> Corrected Exhibit - for Fire re-submitta APPL NO. P22-03146 EXHIBIT A-1 DATE 12/08/22

> SITE PLAN **PROPOSED**

APPL. NO. P22-03146 EXHIBIT E-1 PLANNING REVIEW BY TRAFFIC ENG. CITY OF FRESNO DARM DEPT

SHEET NO. AI.I

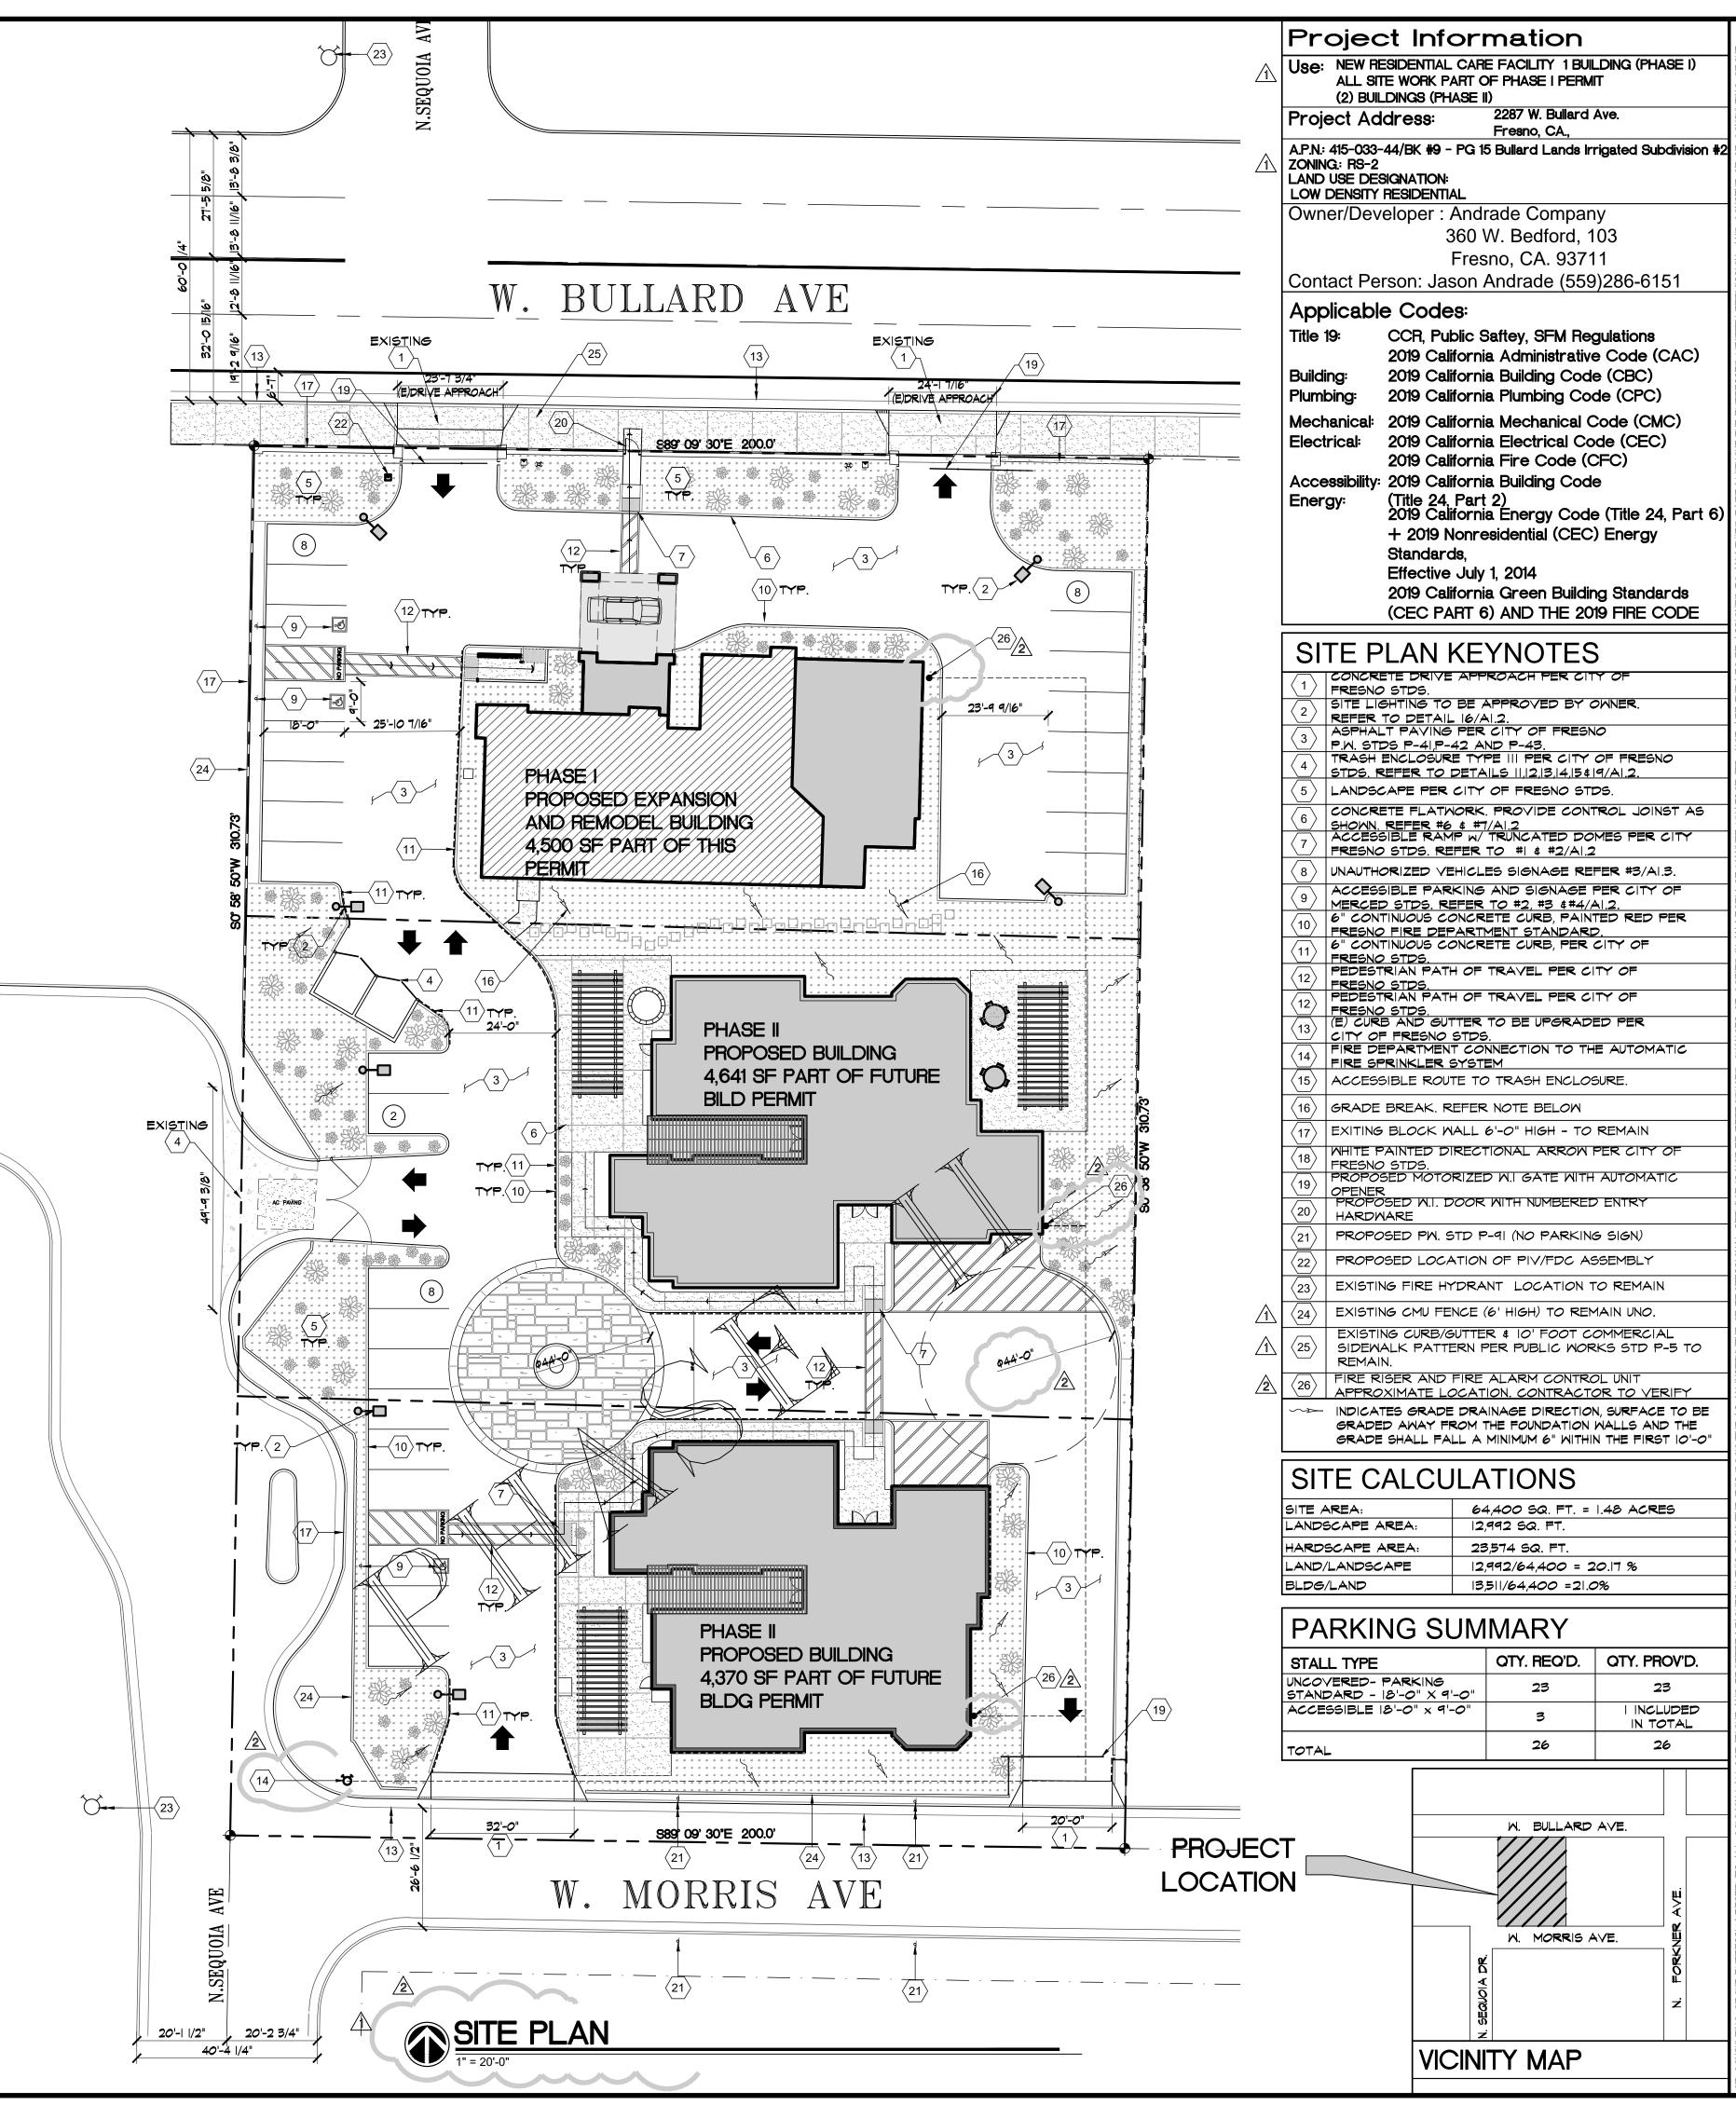
> 8. Turns in private drives for fire apparatus access shall have minimum 44 foot centerline turn radius. The turn radius cannot be met on the east side of the complex next to Phase II Building (4,370 sq. ft.).

II. All gates across fire hose and equipment access points shall be a minimum of 4 foot clear width. There is only one pedestrian gate shown but appears it does not meet this requirement. 12. All required fire hose and equipment access gates shall remain
